Subject: CHIRP NOISE FROM RIGHT REAR AT 60 MPH OR MORE	Bulletin No: 09-001/13
	Last Issued: 11/11/2013

- This bulletin supersedes the previous bulletins 09-001/13 issued 02/15/13 and 09-018/12 issued 04/20/12. The APPLICABLE MODEL(S)/VINS, DESCRIPTION, REPAIR PROCEDURE and WARRANTY INFORMATION have been revised.
- Changes are noted below in Red beside the change bar.

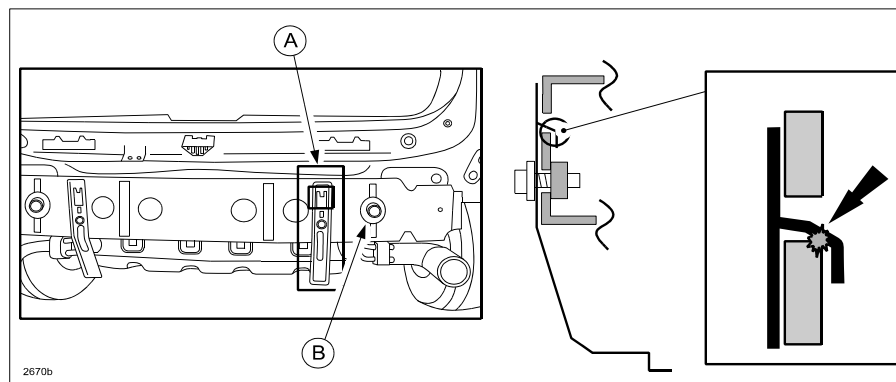
The chirp noise may be caused by the right side rear bumper stay hook (A) contacting the bumper reinforcement (B) at high speed. The shape of the reinforcement hole has been changed on both sides to eliminate the noise. Also, pads have been added to the bumper stay to prevent contact noise.

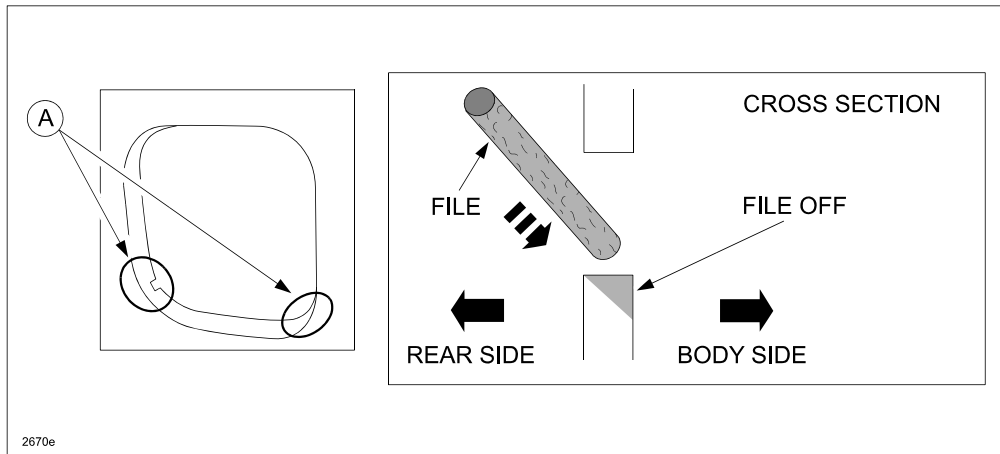
6. File off the inside of both lower hole corners (A) as shown below.

- File off the shaded area until there is no contact between the bumper stay hook and bumper reinforcement.
- Clean the area with an air hose.

7. After cleaning the filed areas, apply touch-up paint to prevent rust.

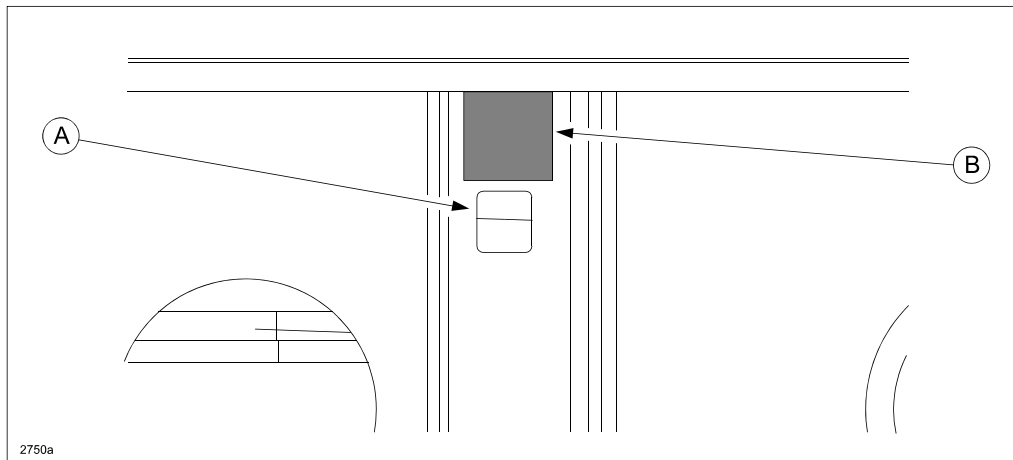
8. Select a 0.25mm thickness sheet from the "Noise Repair Kit". Cut the sheet into the (6) six following size pieces:

- 4 pieces - 20 x 20mm
- 2 pieces - 20 x 10mm

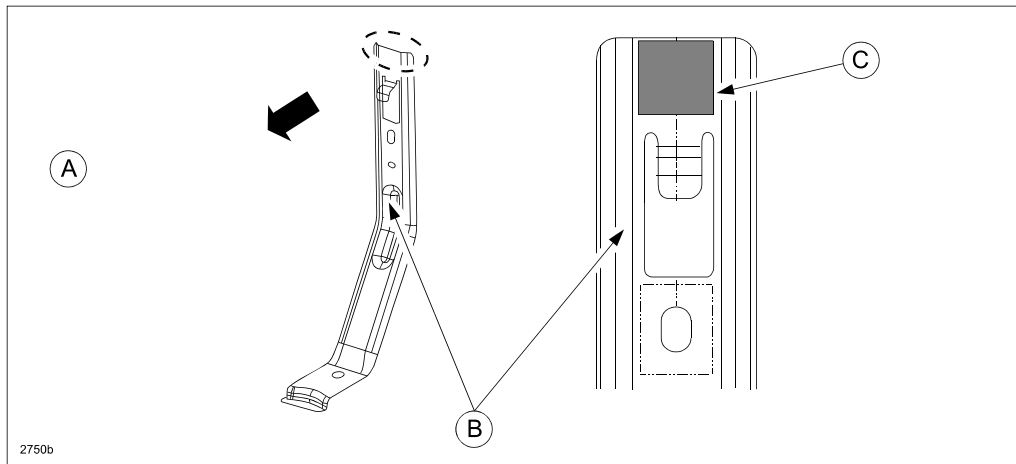
9. Apply (1) one 20 x 20mm pad (B) along the upper edge of the bumper reinforcement, above the hole for hook (A). Repeat Step 9 on the opposite side of vehicle.

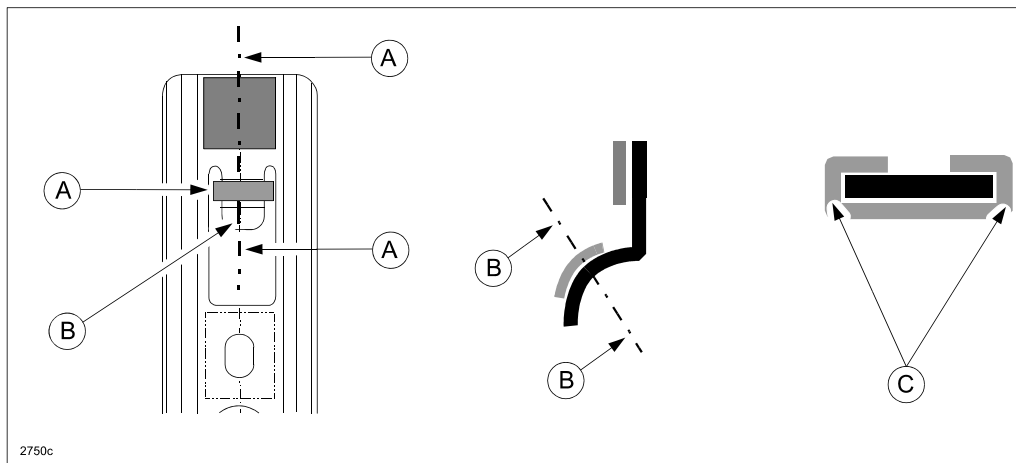
10. (a) Apply (2) two 20 x 20mm pads (C) on the front side of each bumper reinforcement (A), at the upper part of the bumper stay (B).

- (b) Apply (2) two 20 x 10mm pads (A) on the hook (B) of bumper stay. Wrap the pad (C) around both edges of the hook.
